**DEPARTMENT OF TRANSPORTATION
STATE OF GEORGIA**

FILE P.I. #0001585 **OFFICE** Design Policy & Support
NHS00-0001-00(585)
GDOT District 5 - Jesup
Glynn County **DATE** February 28, 2012
I-95 @ SR 99 - Interchange Reconstruction

SUBJECT APPROVED REVISED CONCEPT REPORT

**DEPARTMENT OF TRANSPORTATION
STATE OF GEORGIA
REVISED PROJECT CONCEPT REPORT**

TYPICAL SECTIONS

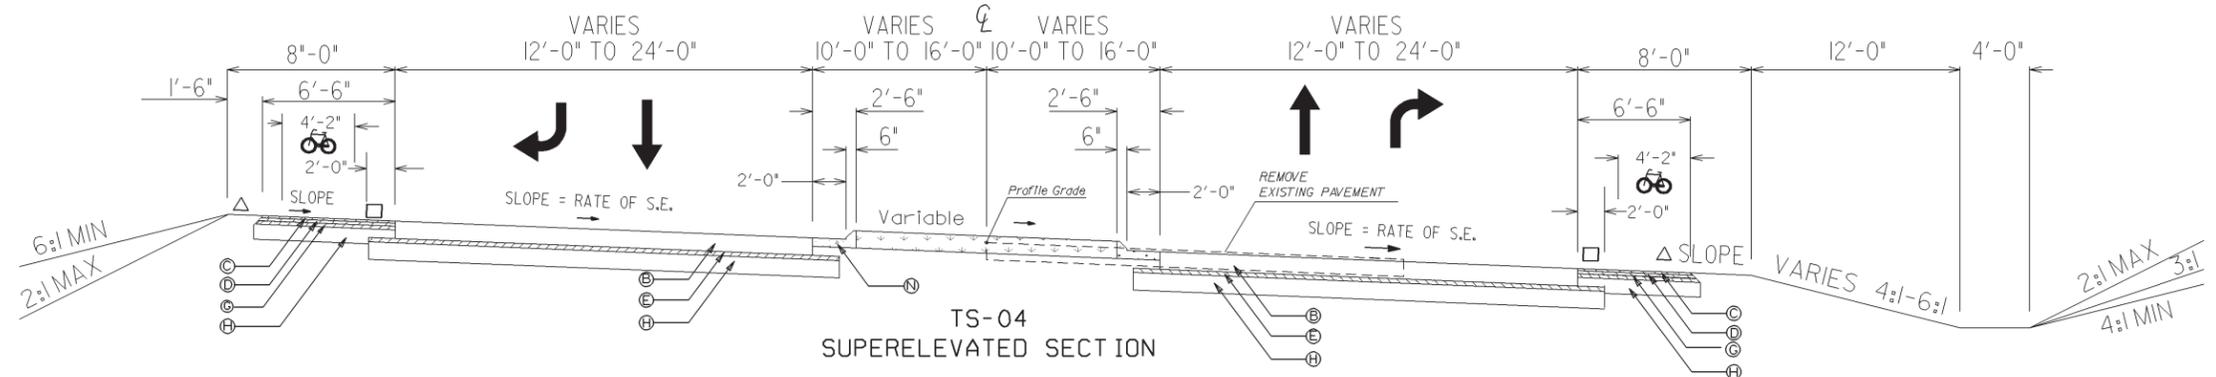
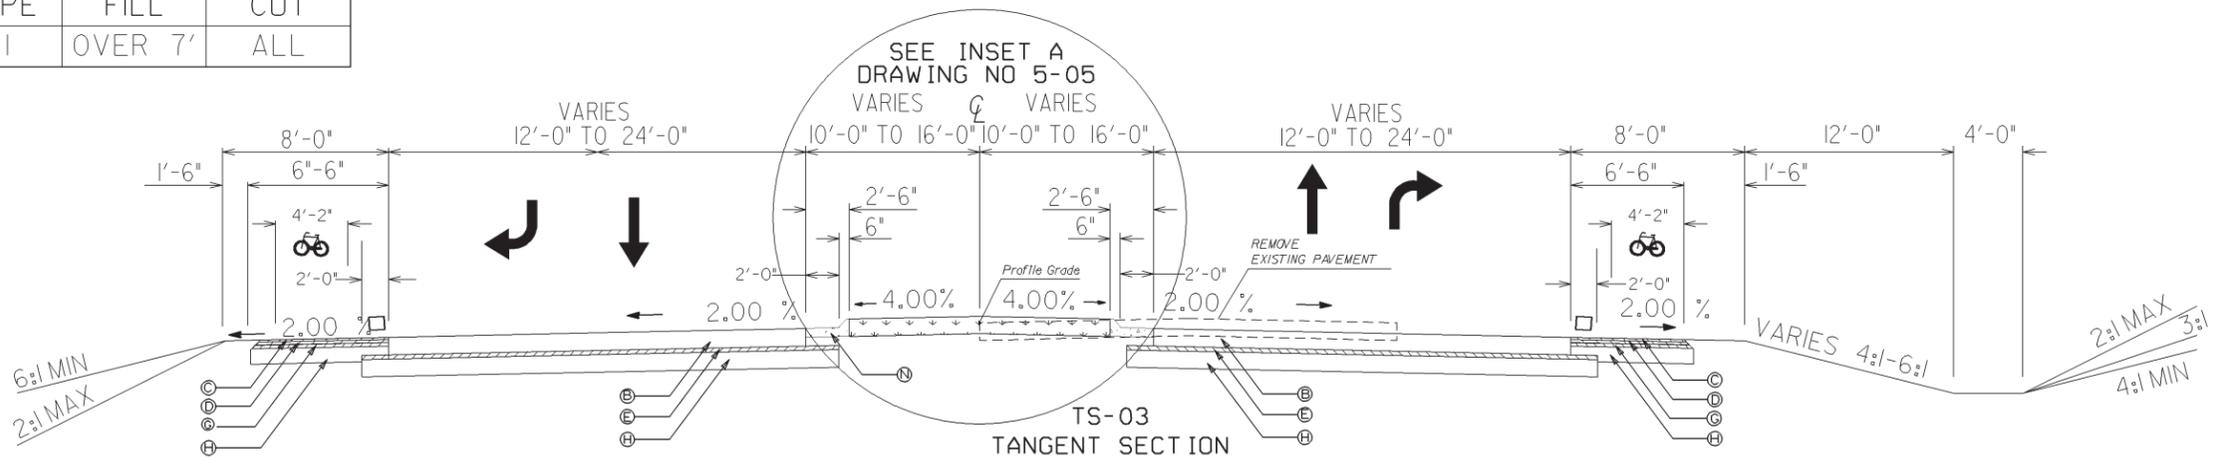
Approved Features:	Proposed Features:
<p>Typical Sections</p> <p>The approved typical sections for the mainline are four 12-ft lanes, 12-ft turn bays along SR 99, varied width raised median (20 to 32-ft) and a 6.5-ft paved shoulder that include a 4'2" bike-able shoulder for a total shoulder width of 12-ft.</p> <p>Ramps</p> <p>The approved typical section for the ramps are four 12 to 14 ft lanes a 12-ft full depth outside shoulder and a 6-ft full depth inside shoulder.</p>	<p>Typical Sections</p> <p>The proposed typical sections throughout the entire mainline will be two 12-ft lanes, 12-ft turn bays along SR 99, a varied width raised median (8 to 32-ft), a 6.5-ft paved outside shoulder on both shoulders that include a 4'2" bike-able shoulder for a total shoulder width of 8-ft.</p> <p>Ramps</p> <p>The proposed ramp typical section will be one 16-ft lane with a 10-ft full depth outside shoulder and a 4-ft full depth inside shoulder.</p>

<p>Reason(s) for change: The reason for this change is the project does not have logical termini for a widening project. Shoulder width revised to meet current design policy. The project termini were corrected to reflect the outermost right-of-way points. This project will alleviate the Design Exception for sub-standard horizontal clearance and sub-standard shoulder widths for the I-95 travel lanes under the SR 99 Overpass.</p>
